PARTS & SERVICE NEWS

REF NO.	AA00172
DATE	July 27, 2000

SUBJECT: REPAIR PROCEDURE OF HOSE CLAMP ON TURBOCHARGER

PURPOSE: To introduce modification procedures to eliminate the breakage of hose clamps used on air supply hoses for turbochargers of twin turbo engines

1) Modification with the hose clamp

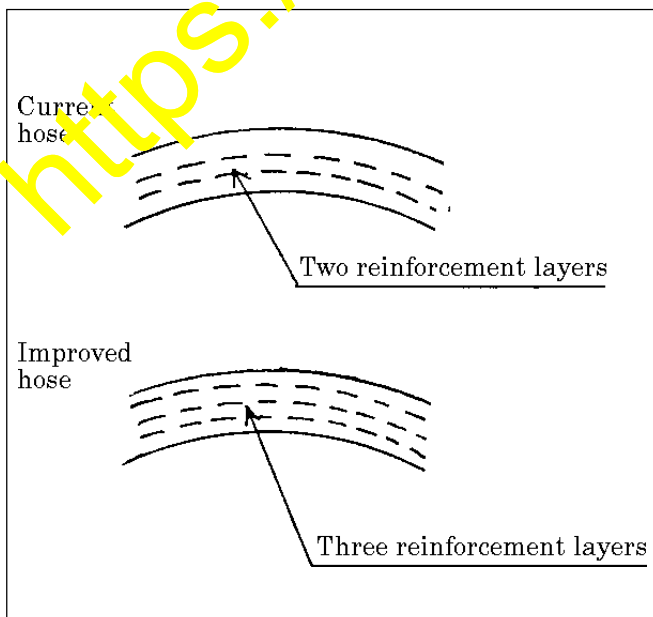
- 1) The shape of the hose clamps used at the outlet port section of the turbochargers has been changed to increase the strength there by to enhance their reliability and durability against breakage.
- 2) The number of the reinforcement layers for the hoses connecting to the outlet port of the turbochargers has been increased to improve reliability and durability to prevent cracking of the hoses when vehicles are used for a long period of time.
(Although the HD465-5 carrying the SAA6D170E-2 engine, WA700AP-1 and WA700-3) are equipped with the improved hoses already, replace them with new hoses when changing the clamps.)

The level difference thus existing in the clamp band has been eliminated to increase the strength.

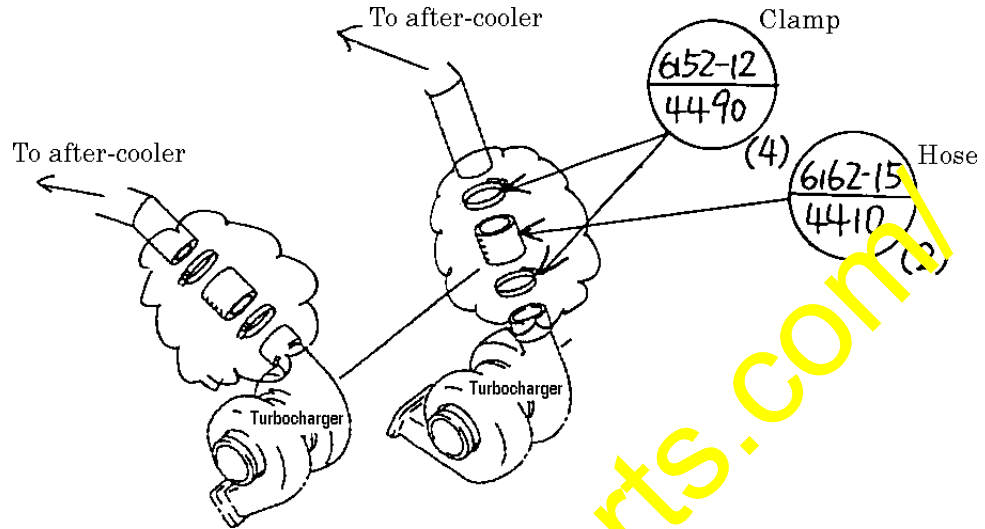
- 1) With the HD465-5, HD465-3 and WA700-1, replace the hoses and clamps shown in the schematic diagrams given below.

※ Hose clamp tightening torque: 9.8N·m (1.0kg·m)
